LANDSCAPE ARCHITECTURE DESIGN REPORT - ADDENDUM 01

New Primary School in Mulgoa Rise

APPLICATION NO. SSD-11070211

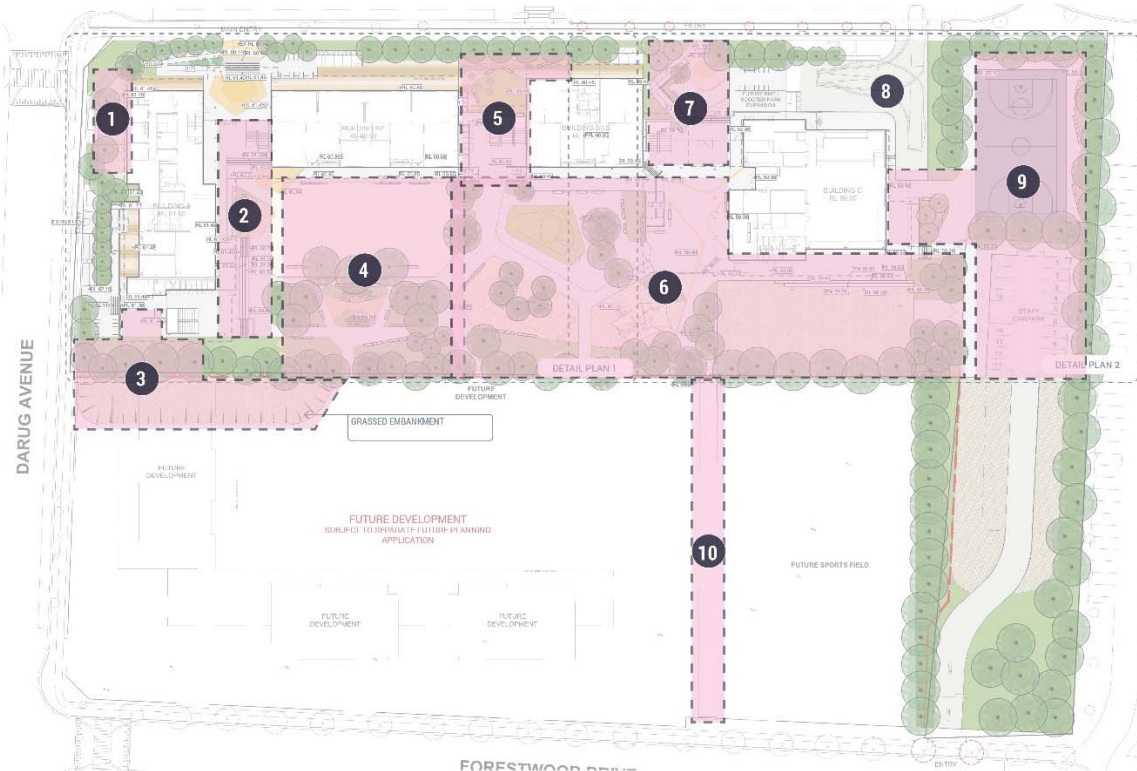
- Rationalisation of hard paved area
- Consolidated seatings
- Revised play areas
- Changes relevant to Building amendments
- Consolidated materials palette

The areas highlighted on the plans (page 8) illustrate the extent of change to the Landscape area, please refer to Legend on page 9 for details of each area (the plans are to be read in conjunction with the legend).

1. Mechanical location revised; lawn area replaced with mass planting
2. Access to Block A from main entry, Block B2, B3S and Block C revised, details as follows

- A. 1:14 ramp in lieu of 1:21 walkway (previously in front of Block A) to allow for a shorter route and more direct access
 - B. Increase in landscape area in lieu of 1:21 walkway

- C. Bleacher seating omitted; stair width increased to accommodate for circulation.
3. Temporary landscaped embankment reduced in size, additional landscaped area in lieu of concrete paving to the west side of stair 1.

4. Assembly area developed
 - A. Pocket landscape area with trees introduced.
 - B. Interpretive Line marking incorporated
 - C. Outdoor learning area updated for Yarning Circle opportunities

- D. Educational Trail / Explorative Play in lieu of concrete paths
5. Outdoor play area to support unit
 - A. Timber decking omitted
 - B. Access ramp revised to suit the new location of toilet block

6. Consolidated sensory play
 - A. Synthetic turf mound location revised
 - B. Yarning Circle opportunities included at mulched play area
 - C. Turf open play area increased

- D. Revised Bleacher Seating to revised COLA extent
 - E. Incidental Nature play
7. New accessible ramp introduced to allow for a more direct access
8. Services area revised

9. Sports & Carpark
 - A. Hard paving reduced around basketball court
 - B. Coloured concrete finish for basketball court in lieu of plexipave
 - C. Emergency vehicle access revised

10. Access to Forestwood drive revised.
